Duquesne Light

SUBJECT: Beaver Valley Power Station - Unit No. 2
Docket No. 50-412
PSB Mechanical Responses

This letter forwards revised PSB Mechanical responses which were accepted at a meeting held on February 11, 1985, and an informal meeting held on February 28, 1985. FSAR changes described in these revised responses will be incorporated in an upcoming amendment. The following responses are attached: 430.25, 430.55, 430.59, 430.107, 430.117, 430.122, 430.123, 430.125, 430.126, and GDC 5 for communications systems.

FIG. 430.123-1
 DIESEL GENERATOR EXHAUST
 CONFIGURATION

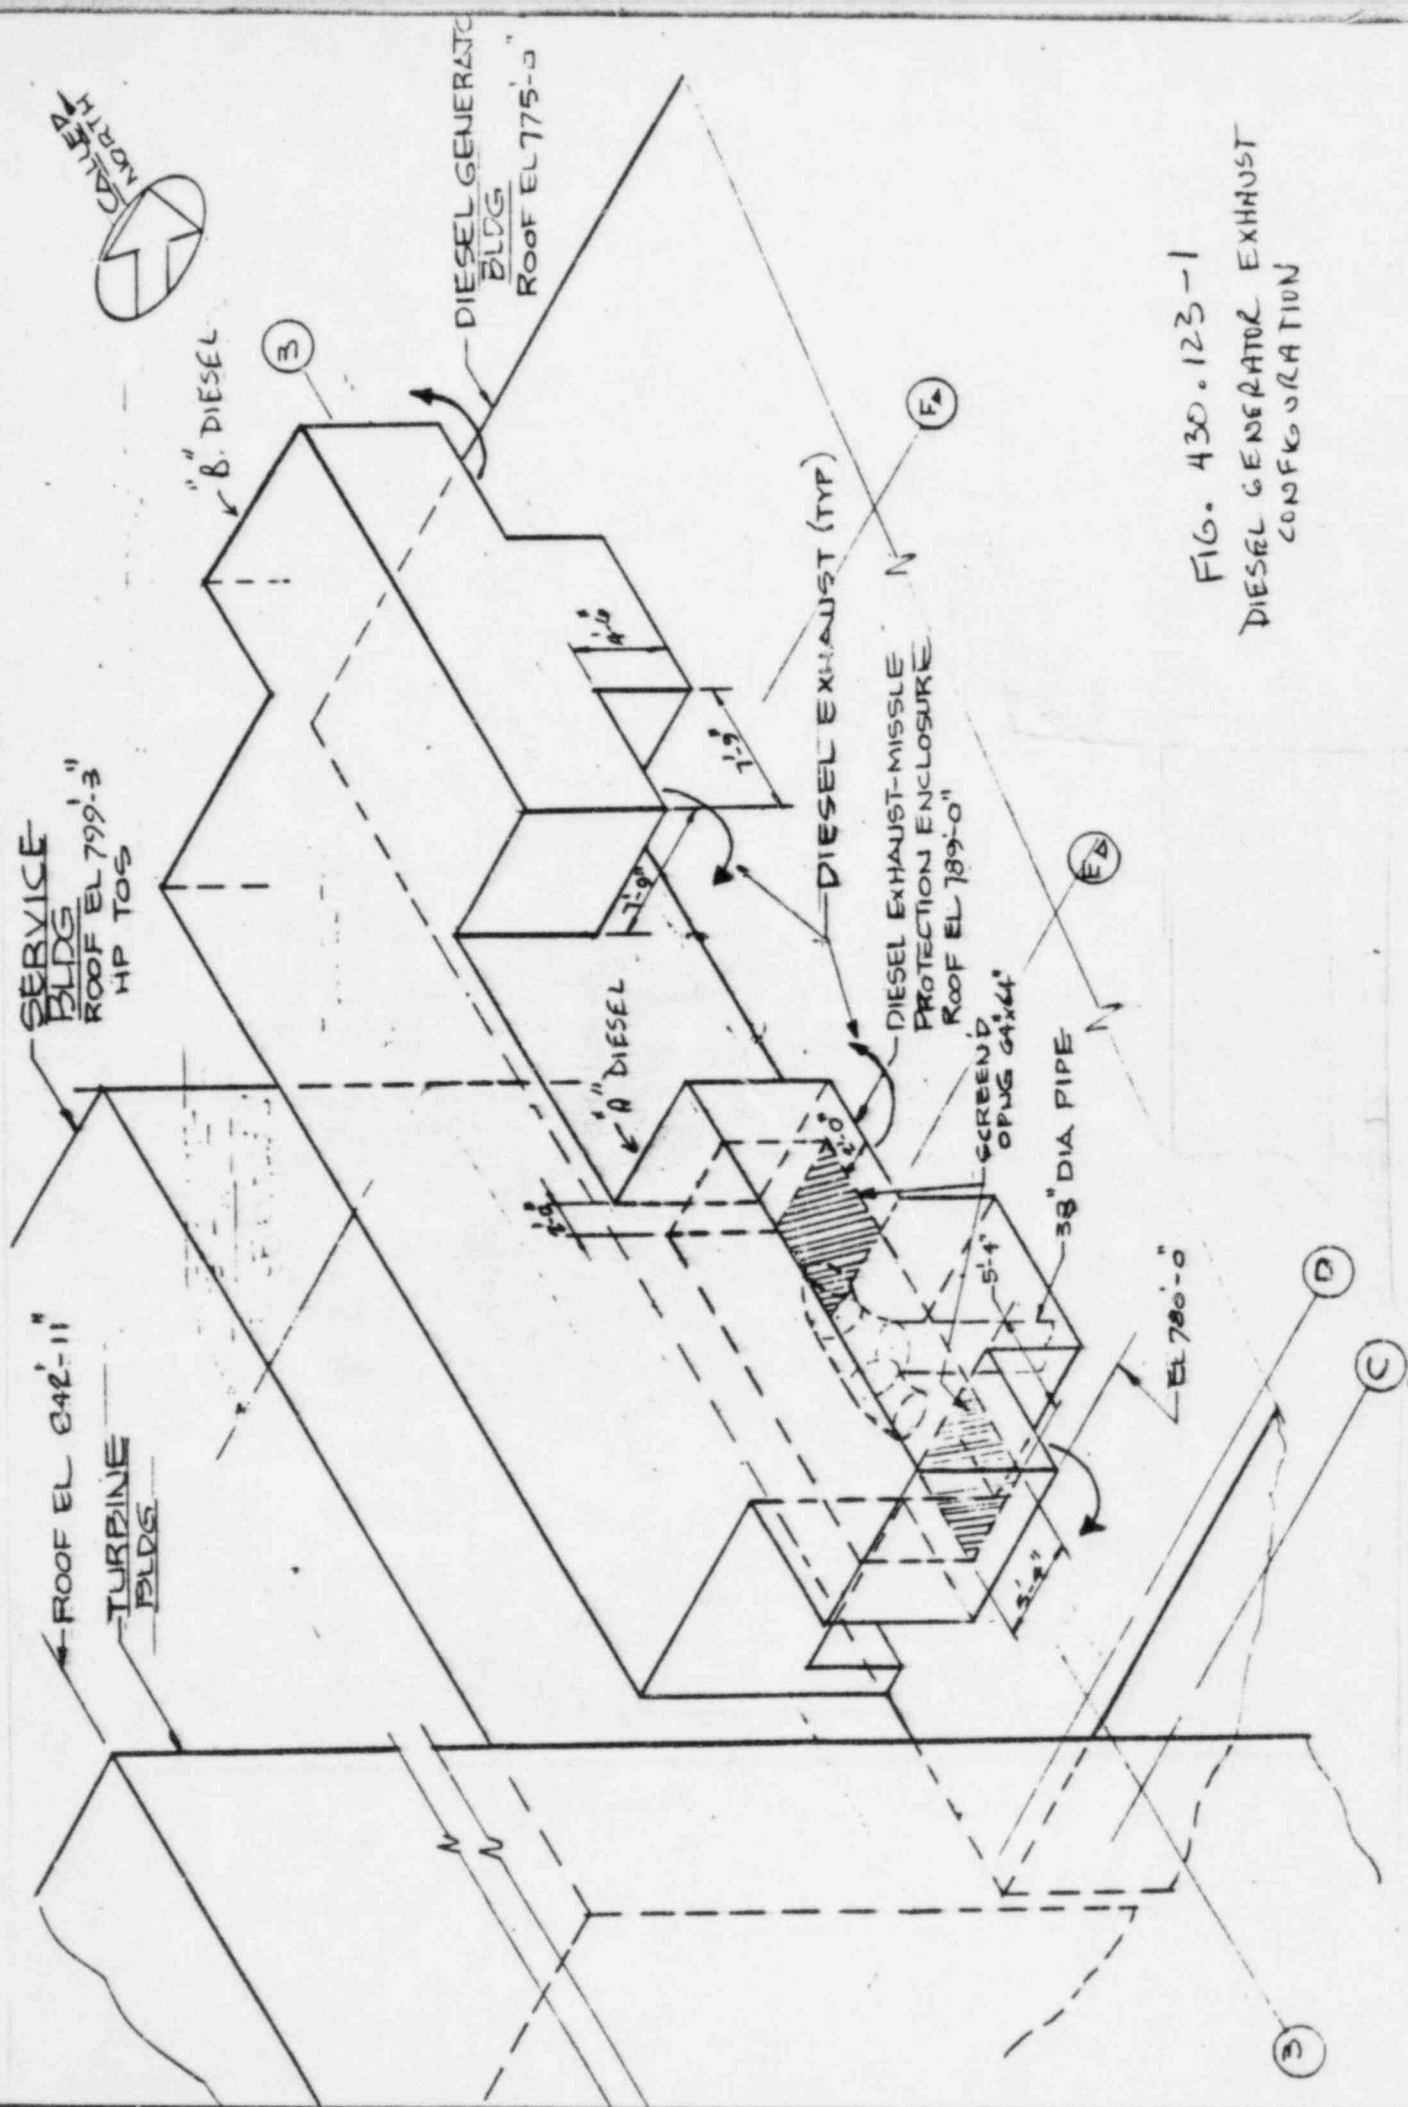
Discuss the provisions made in your design of the diesel engine combustion air intake and exhaust system to prevent possible clogging, during standby and in operation, from abnormal climatic conditions (heavy rain, freezing rain, dust storms, ice and snow drifts, and snow) that could prevent operation of the diesel generator on demand (SRP 9.5.8, Parts II and III).

Abnormal climatic conditions to be considered at BVPS-2 would include heavy rain, freezing rain, ice and snow drifts, and snow. Heavy rain, freezing rain, and snow cannot impair the functioning of diesel intakes and exhausts because of the downward facing openings of the labyrinths which are designed to protect the exhausts and intakes from tornado missiles. Drifting snow cannot restrict intakes due to their elevation, which is greater than 25 ft. above the ground (refer to Figure 3.8-43). Blockage of diesel exhausts by drifting snow is prevented by the location and configuration of the concrete hoods (refer to Figure 3.8-43). Since each hood has two downward facing openings, one on the north side of the center supporting pedestal and one on the south side of the pedestal, blowing snow from the north or south will not significantly drift at least one opening on each diesel exhaust because of shielding by the pedestals and/or the adjacent diesel exhaust hood. Snow blown from the east or west will not drift significantly because the north opening of the "B" diesel exhaust and the south opening of the "A" diesel exhaust permit blowing snow to freely pass under the overhanging openings. In addition, the area of the openings (over 50 ft²) far exceeds the area of the exhaust pipe (less than 8 ft²) and would permit significant screen blockage before diesel performance would be impacted. Snow depth can reach 51 inches average at the diesel exhausts and still maintain the 8 ft² total opening area, assuming the exhaust flow does not blow or melt nearby snow (which it certainly would).

IT CAN EASILY BE SEEN FROM FIGURE 430.123-1 THAT WINDS FROM OTHER DIRECTIONS ALLOW CONSIDERATION OF A COMBINATION OF THE CHARACTERISTICS WHICH PREVENT SIGNIFICANT NORTH-SOUTH OR EAST-WEST DRIFTING.
